Access Compliance Report

Public Rights-of-Way

(Curb Ramps)

Intersection ID: 10035582	Main Street: REAMES_RD	Cross Street: N/A	Location: E
ADA ID: 8C590ACD6D71	Ramp Type: Perp	Initial Pass/Fail: Fail	Overall Compliance: No
Codes/Mitigation Info/Possible Solution		Field Measurements/Component Compliance	
Severity Score: 8.75

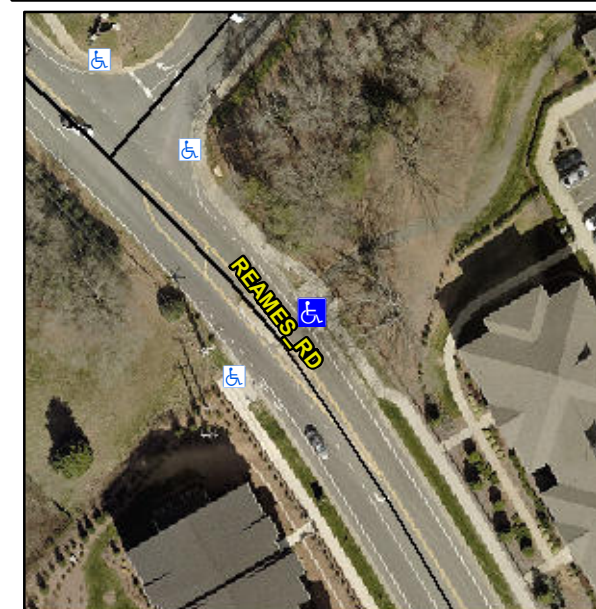
Not Found, R304.5.1

Compliance	Description	Data	Compliance	Description	Data
N/A	Ramp Length (in)	83.0	Yes	Ramp Slope (%)	7.7
No	Ramp Width (in)	36.0	Yes	Ramp XSlope (%)	1.6
N/A	Flare Type LT	N/A	N/A	Flare Type RT	N/A
N/A	Flare Slope LT (%)	N/A	N/A	Flare Slope RT (%)	N/A
N/A	Flare Traversable LT?	N/A	N/A	Flare Traversable RT?	N/A
N/A	Landing Length (in)	N/A	N/A	DWS Provided?	N/A
N/A	Landing Width (in)	N/A	N/A	DWS Contrast?	N/A
N/A	Landing Slope (%)	N/A	N/A	DWS Length (in)	N/A
N/A	Landing X Slope (%)	N/A	N/A	DWS Full Width?	N/A
N/A	Landing Curb? (Y/N)	N/A	N/A	DWS Offset (in)	N/A
N/A	Shared Landing?	N/A			
N/A	Gutter Ponding?	N/A	N/A	Gutter Slope (%)	N/A
N/A	Gutter Lip Ht (in)	N/A	N/A	Gutter X Slope (%)	N/A
N/A	Painted X Walk1?	No	N/A	Painted X Walk2?	N/A
	X Walk 1 Direction	To W		X Walk 2 Direction	N/A
N/A	X Walk 1 Width (in)	N/A	N/A	X Walk 2 Width (in)	N/A
	X Walk 1 Slope (%)	5.3		X Walk 2 Slope (%)	N/A
	X Walk 1 X Slope (%)	1.3		X Walk 2 X Slope (%)	N/A

Remove & Replace Entire Ramp.
